MOONEY AIRCRAFT, INC.

SERVICE LETTER 20-71

SERVICE BULLETIN M20-71

DATE: July 26, 1960

FIGURE 1
View looking fwd. and inboard from right

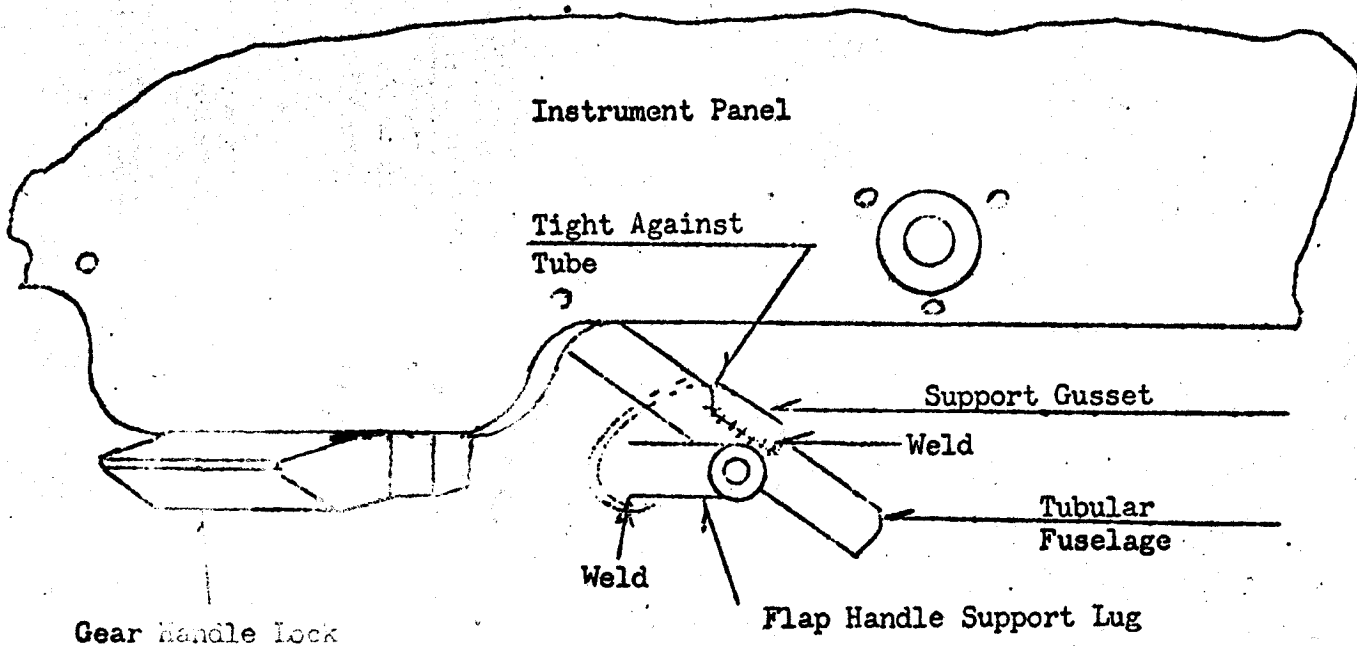
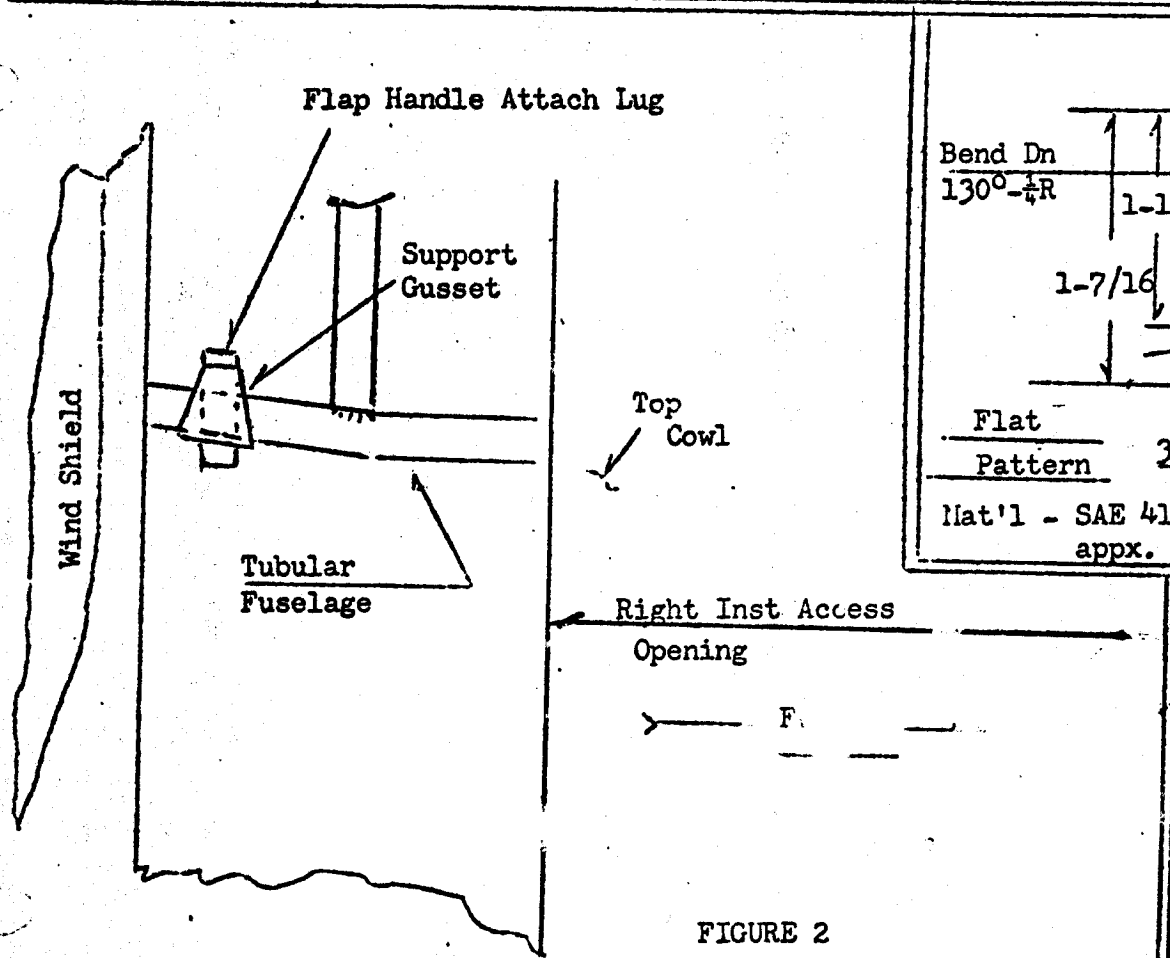
Effective on Mooney aircraft Serial Nos. 1002-1571. A method of improving the flap handle support bushing locally is contained in the following repair instructions for use by your A&E mechanic. Failure of the attachment could result in loss of flap control. It is therefore recommended that the security of this attachment be checked and that it be reworked in accordance with the following instructions:

1. Remove flap control handle and attached control tube.
2. Protect items near the area to be welded. Remove or loosen instrument panel attachments (including nuts on vernier controls) in area above flap handle, pull panel back and insert wet asbestos behind panel. Place wet asbestos around throttle control housing. Loosen clamps on wiring loom, push it away from area to be welded and wrap it with wet asbestos.
3. Weld up any cracks on front outboard side and back of flap handle attach lug. Add weld along outboard side if this area is not presently welded.
4. For added strength, it is recommended that a support gusset be made and installed as shown in figure.
5. Clean, Prime and paint weld area.
6. Install parts removed.
